**TOWN OF NEWBURGH  
PLANNING BOARD  
TECHNICAL REVIEW COMMENTS**

**PROJECT: GARDNER RIDGE**  
**PROJECT NO.: 2002-29**  
**PROJECT LOCATION: SECTION 75, BLOCK 1, LOT 4.12**  
**REVIEW DATE: 1 MARCH 2016**  
**MEETING DATE: 3 MARCH 2016**  
**PROJECT REPRESENTATIVE: TOM OLLEY AND DARREN DOCE, P.E.**

**THOMAS B. OLLEY, P.E., P.L.L.C.**  
ENGINEERS AND PLANNERS  
85 ORANGE AVENUE  
WALDEN, NY 12586  
PHONE (845) 796-8338  
FAX (845) 796-8187

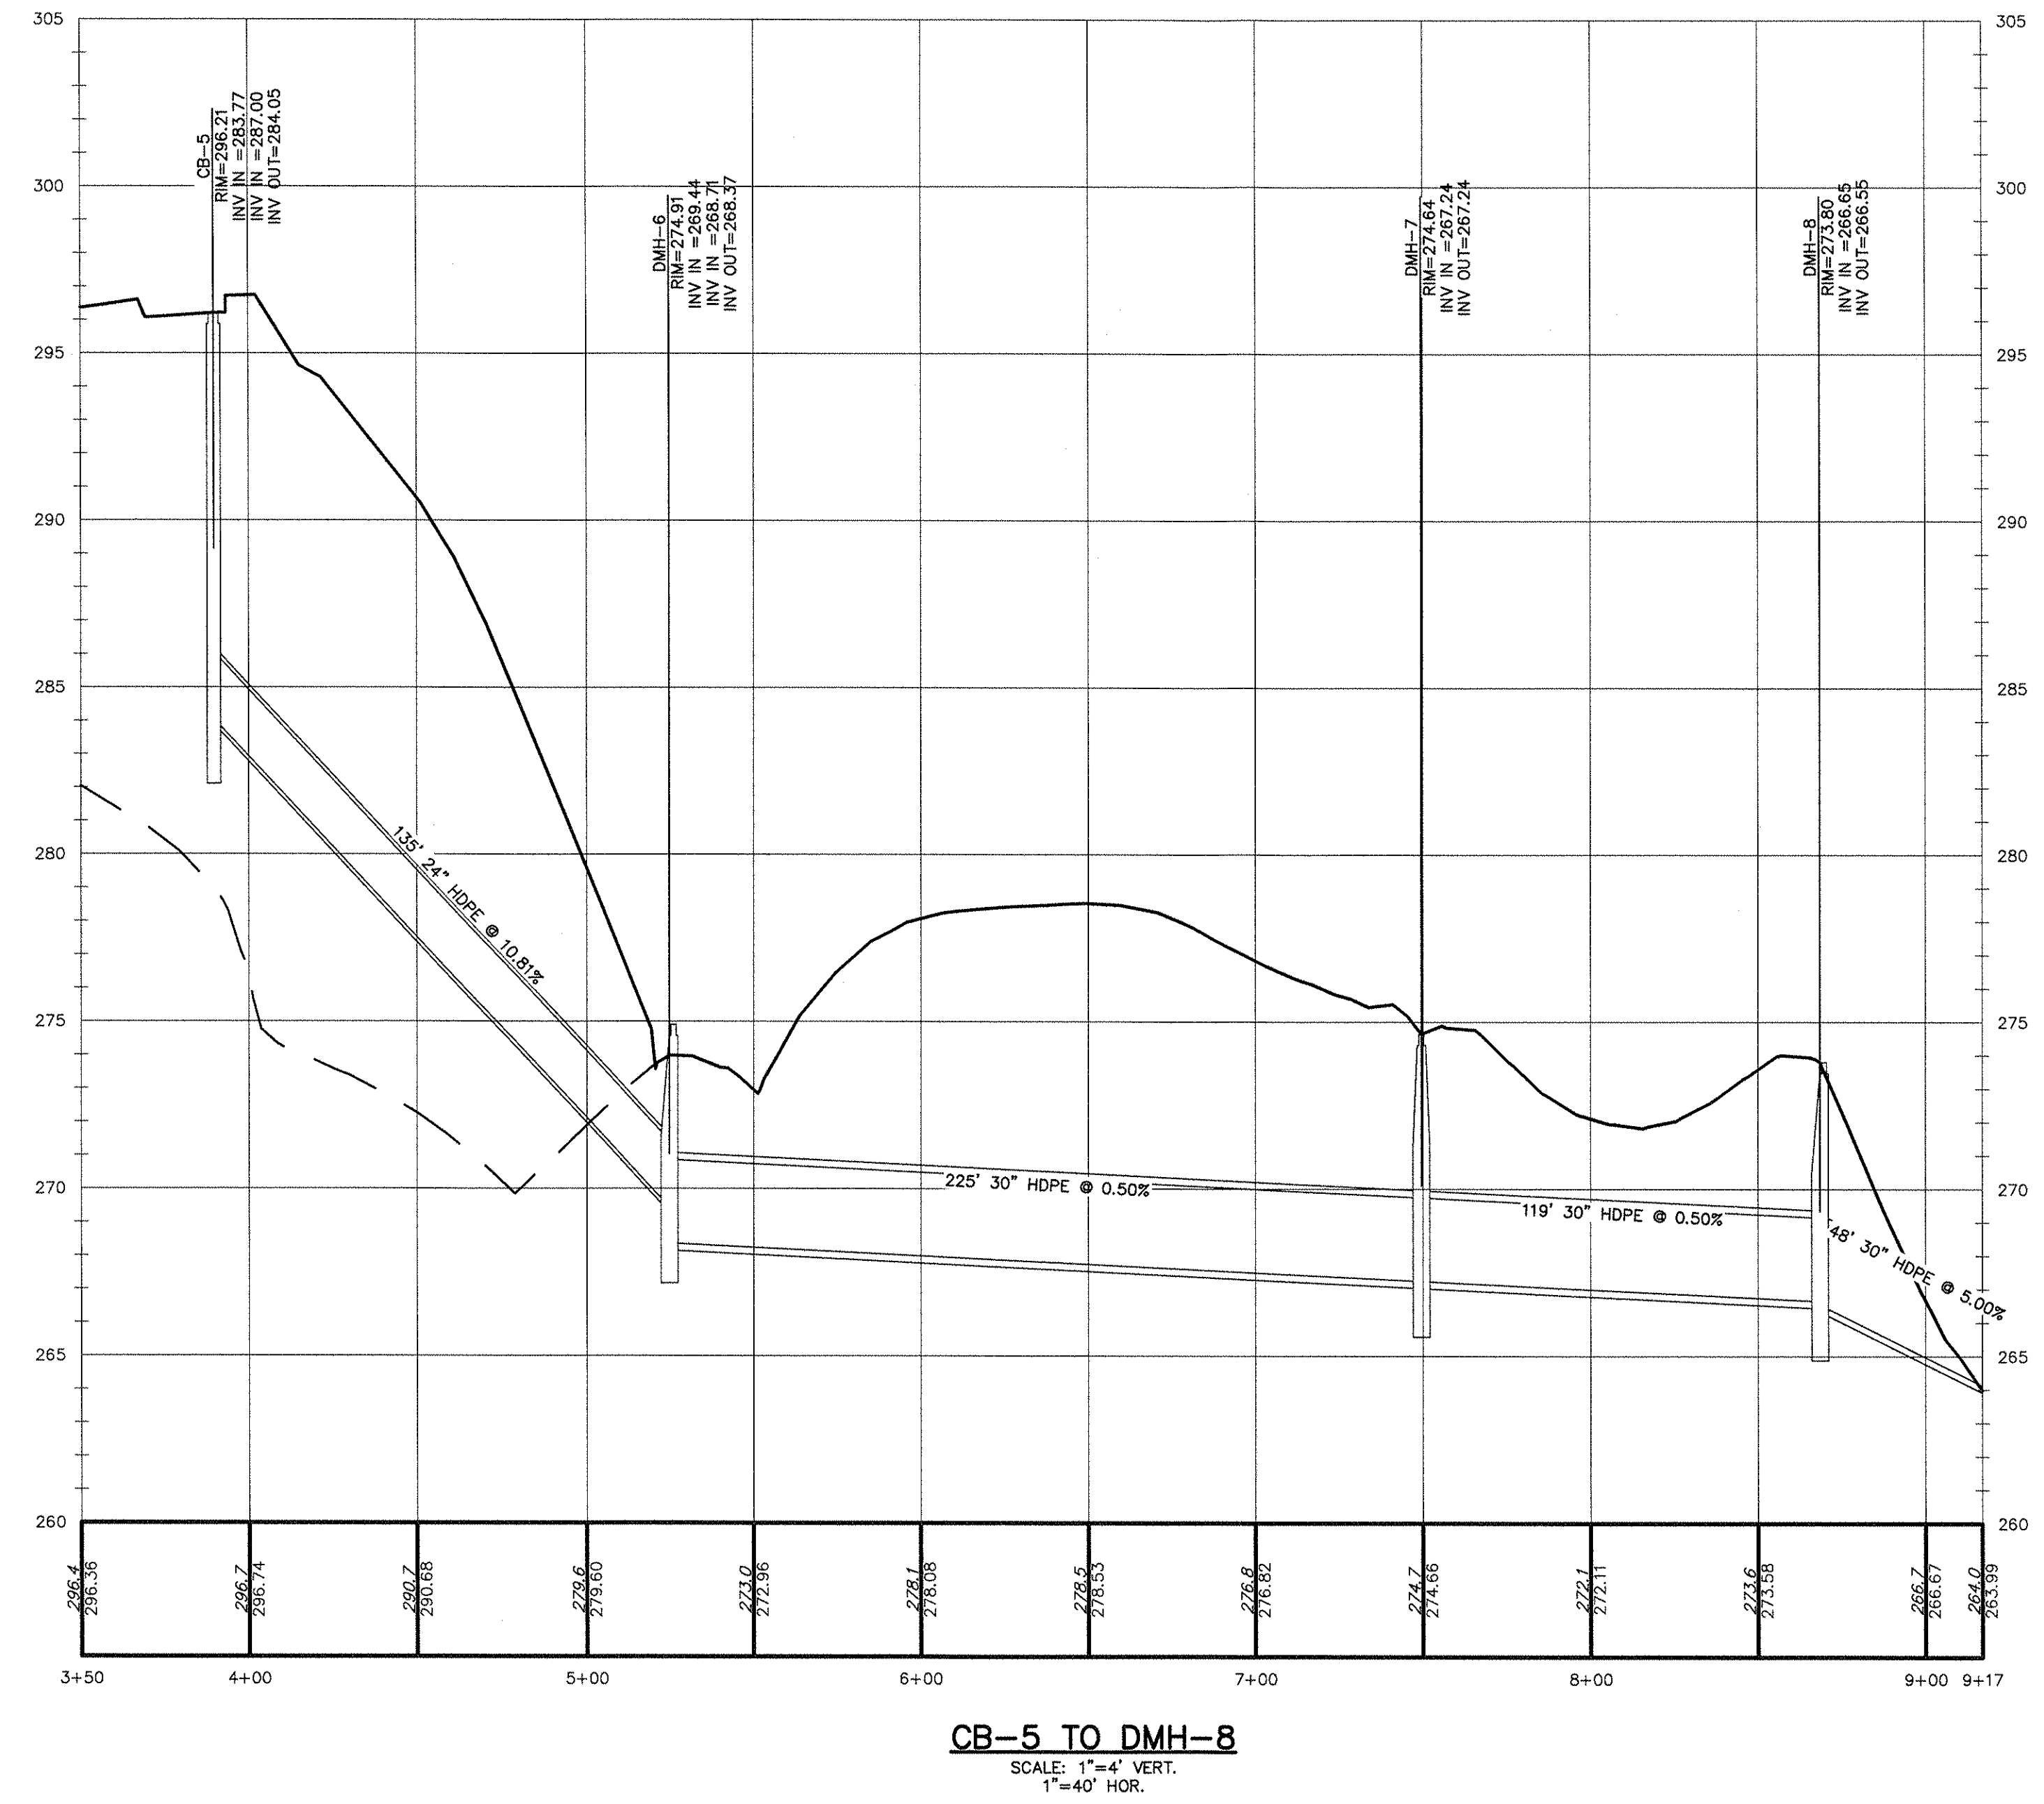
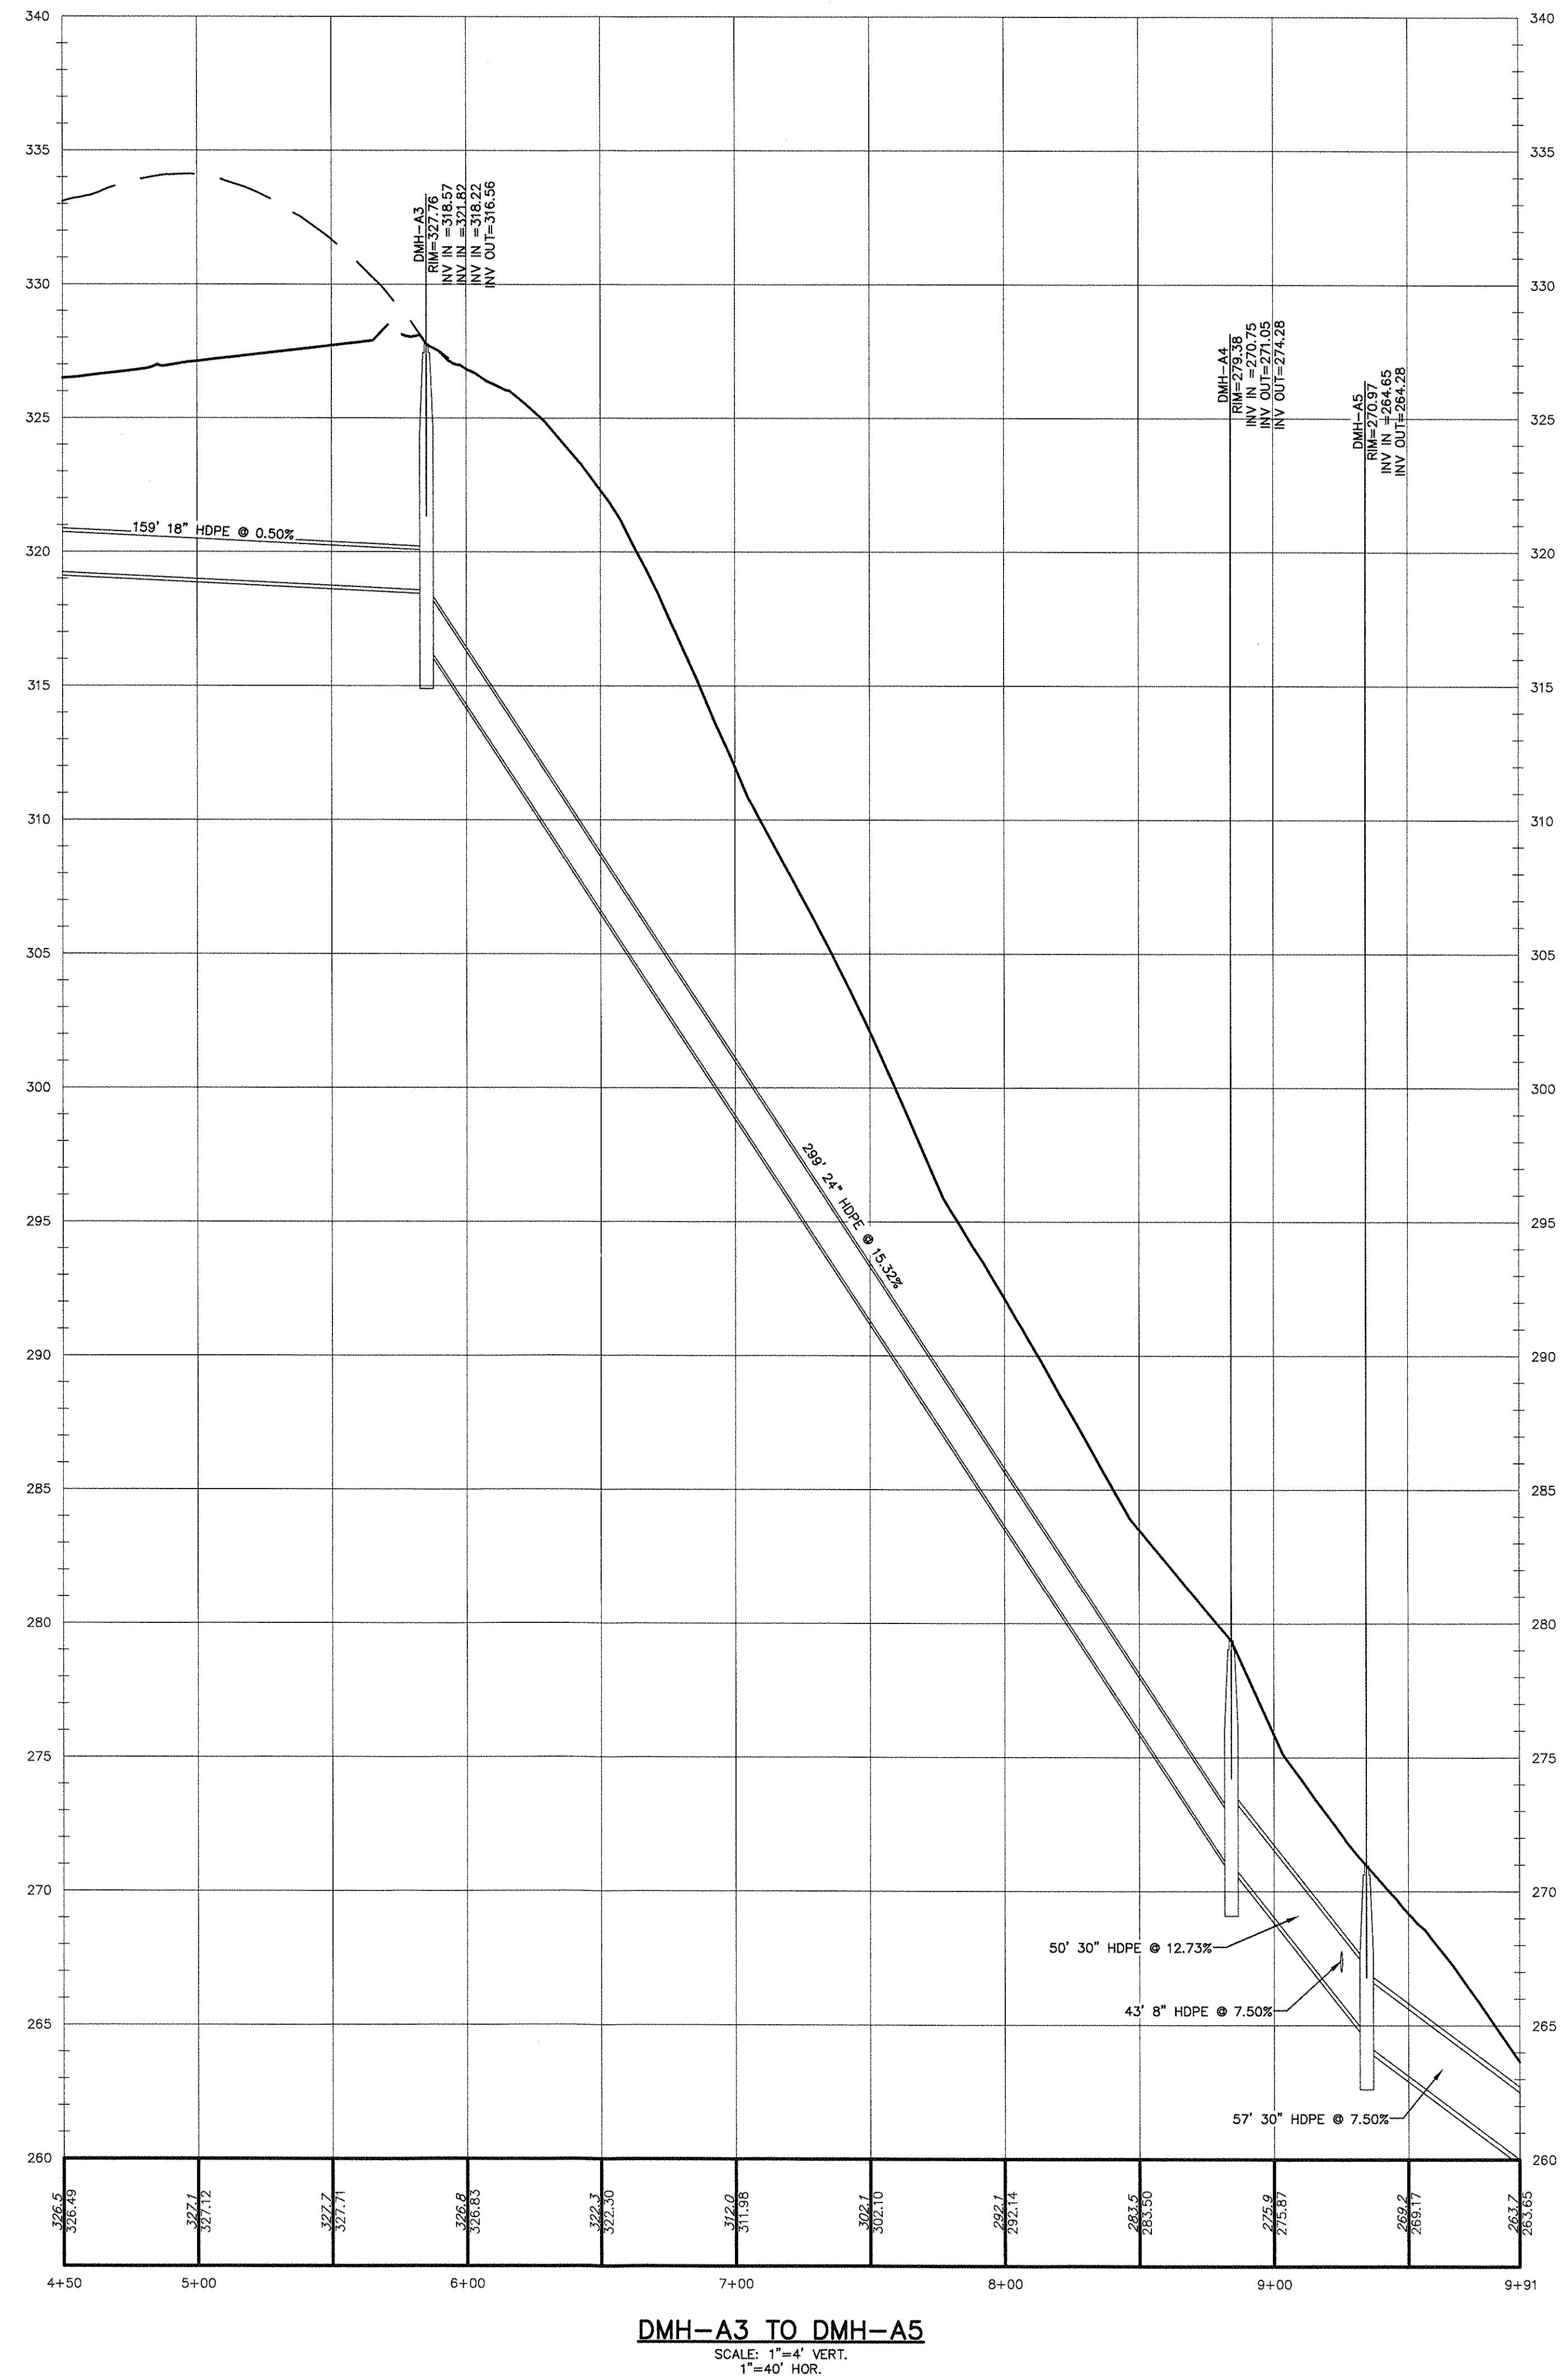
15. Future submissions must address on site landscaping.
16. Road profiles for Emergency Access Roads should contain design information regarding vertical curve data. Stormwater Management for discharge down the Emergency Access Road must be addressed. Pipe size at Emergency Access Road connection with Town Roads should be depicted along with inverts.
